Royal Berkshire Hospital - Integrated Care Service - Elective Recovery RBH-ICS ER

Proposed GA First Floor / Roof Plan

Job Number	Date	Security Classification	Drawn By
146891	31-05-2024		MJS
Scale@A1	Purpose	Reviewed By	
1 : 100	STAGE 4 ISSUE	AG	
Drawing Number	Revision	Suitability	
RBHU-AUK-XX-01-PL-A-200111	P04	S4

Proposed GA First Floor
1 : 100

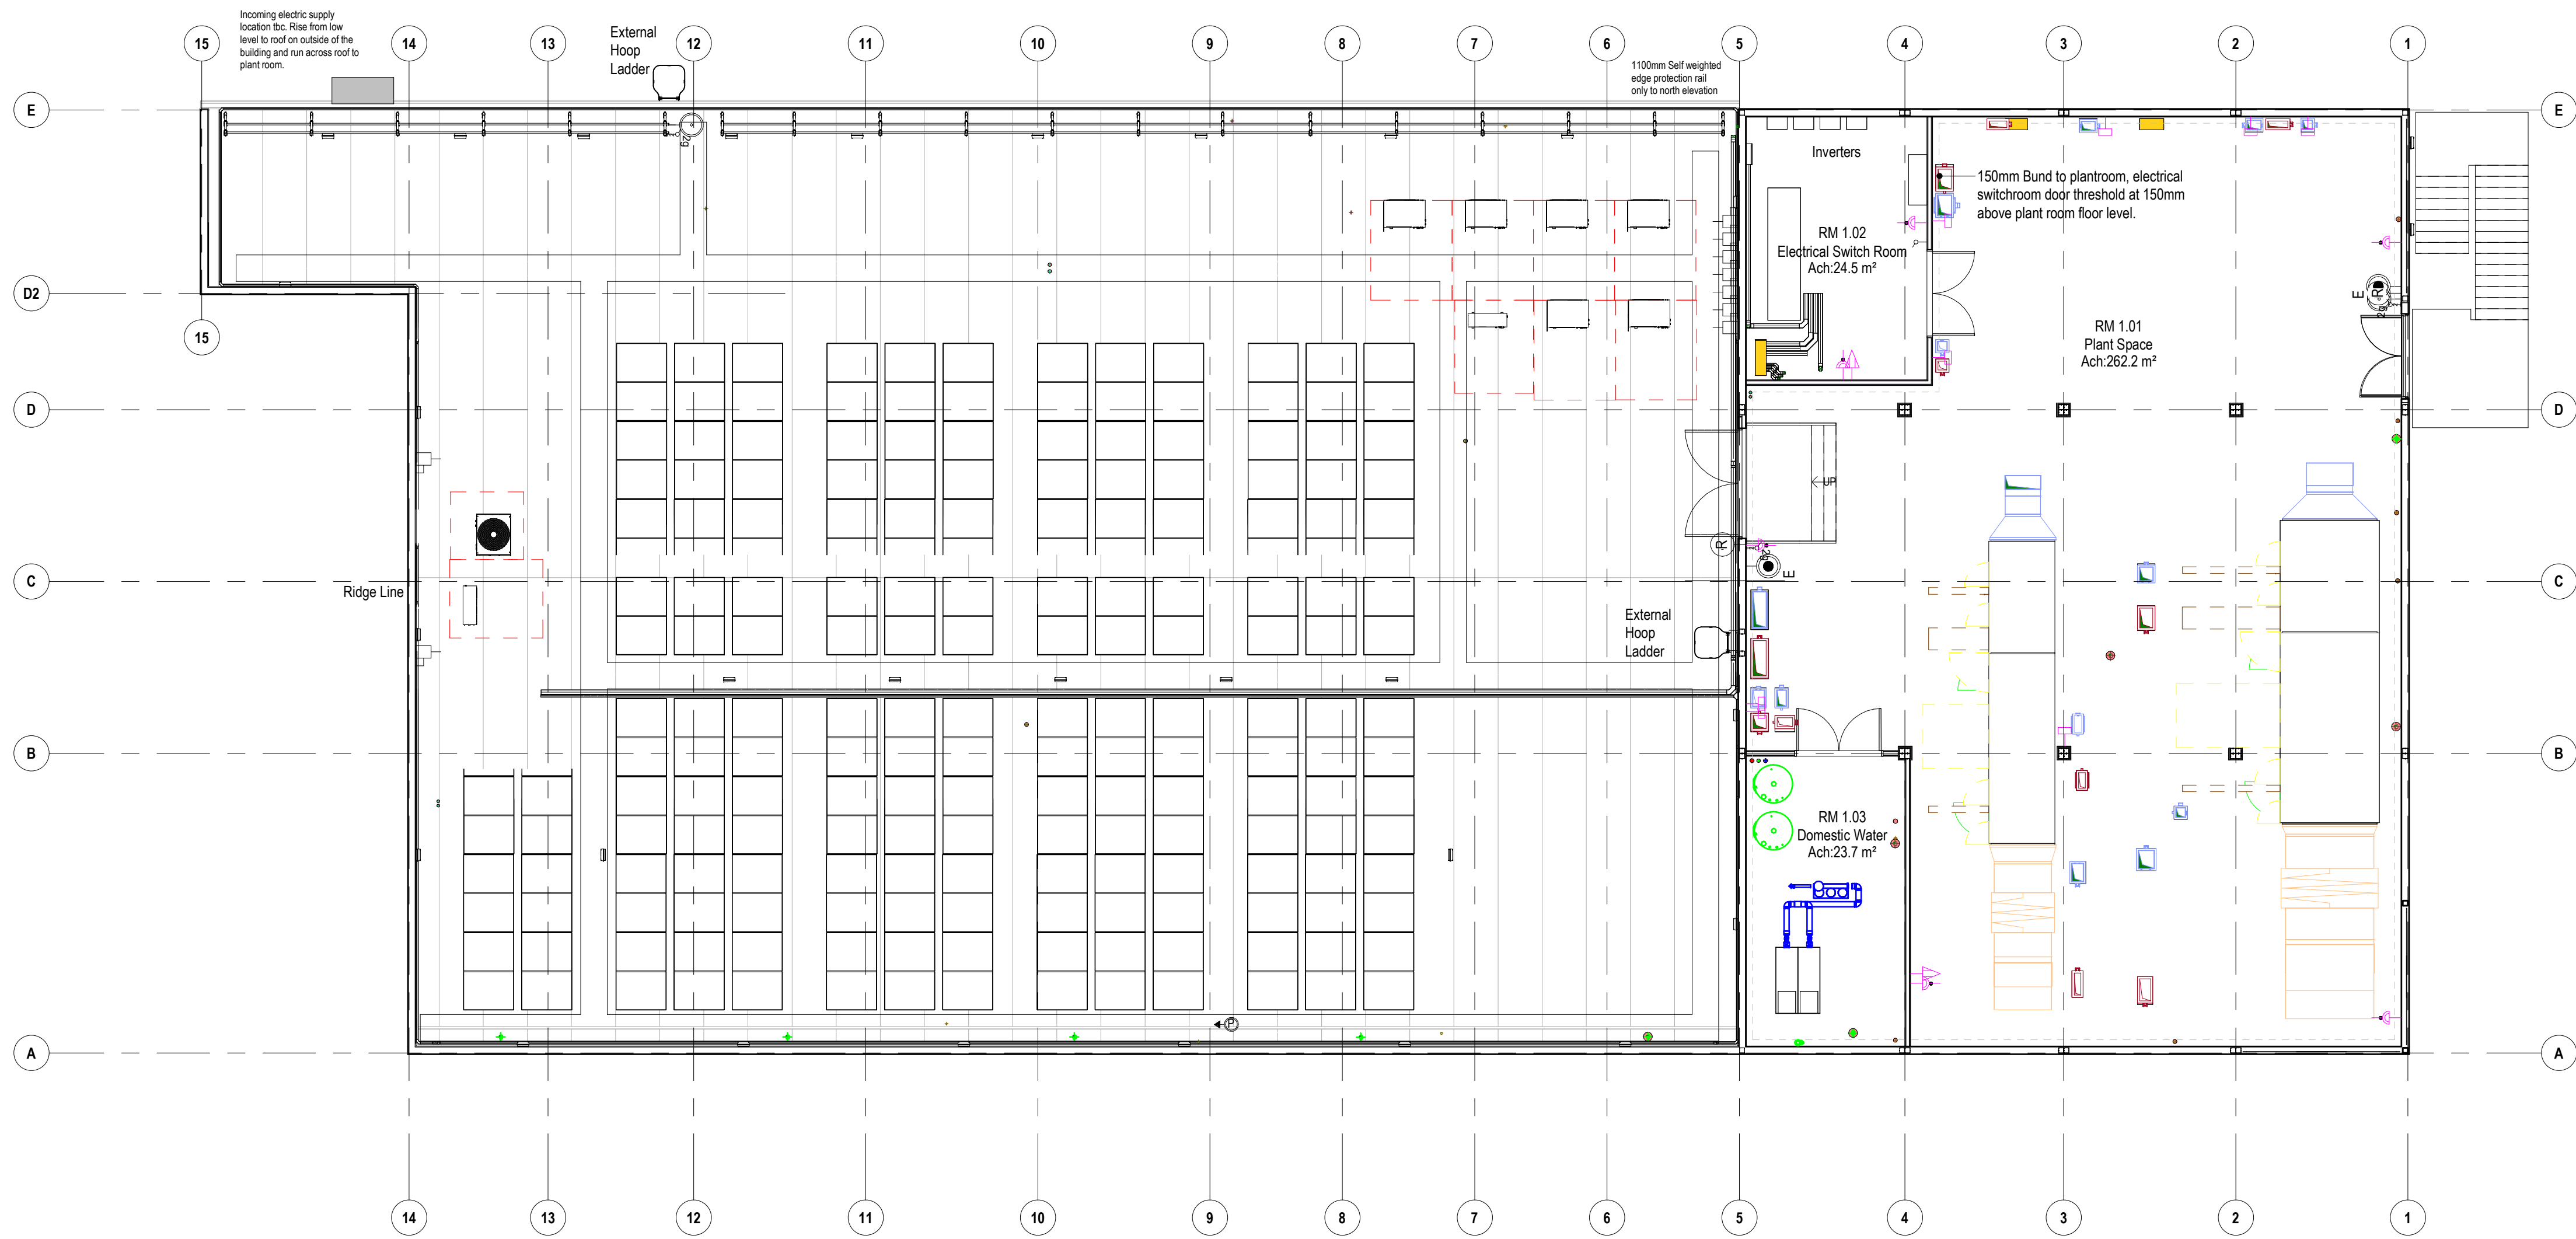
P04	03/10/2024	Stage 4 Issue	MJS	AG
P03	18/07/2024	External Plantroom door increased to 2500wx2400h structural opening following MEP discussion, external hooped cat ladder moved to be 2000mm clear of the increased size door. Note added regarding Plant room 150mm bund.	MH	AG
P02	12/07/2024	Stage 3 Issue	MJS	AG
P01	FIRST ISSUE		MJS	AG
Rev	Date	Revision Notes	Drawn	Review
